Alberta Hot Line Inc

Re: Proposed Damage Prevention Regulations and Draft Guidance Notes, February 2009

Proposed Regulatory Text² – Guidance Notes

THIS DRAWING IS AN EXAMPLE OF THE DEPTH OF COVER VARIANCES.

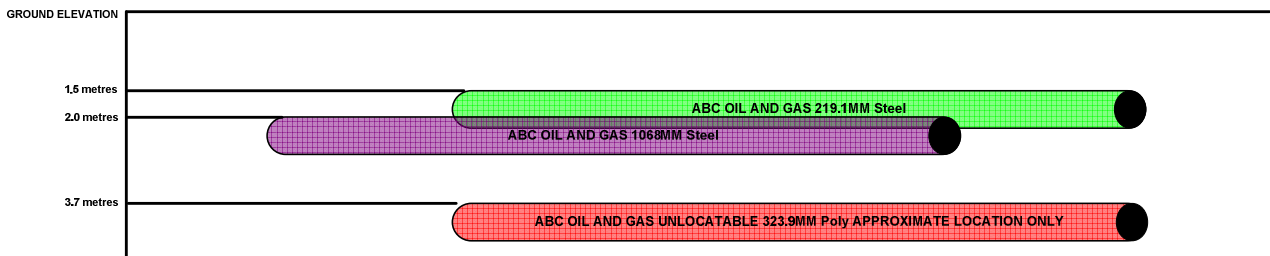
Pipelines and utilities are not always located in the middle of the Right-Of-Way. A locator may encounter difficulties, such as lost signal, field distortion, ghosts, depth wandering, differing soil types, and proximity to other conductors. Deeper pipelines and utilities have been installed using tunnel construction (i.e. boring or directional drilling). Tunnel construction is becoming more common place in the underground infrastructure making it more difficult or impossible to locate using electronic equipment. Some pipelines may run through a sleeve or casing that may cause a loss of signal response along its length. In addition, different compositions of target facilities and poor construction methods can lead to distorted readings which can lead to inaccurate locates. An un-locatable pipe or facility is impossible to measure from and cannot be assumed to be constructed in the centre of a right-of-way. Whenever the aforementioned difficulties arise, AHL strongly recommends the safety zone should be measured from the edges of the right of way and not from (30) metres from the centreline of a pipe.

See drawing below for visual reference.

THE SAFETY ZONE MUST BE MEASURED FROM THE EDGES OF THE RIGHT OF WAY
WHENEVER DIFFICULTIES ARISE IN LOCATING, OR RECORDS ARE INCOMPLETE OR INACCURATE.

Some buried facilities depths are greater than 15 metres.
Most standard pipe and cable locators cannot locate signals beyond 3 metres.
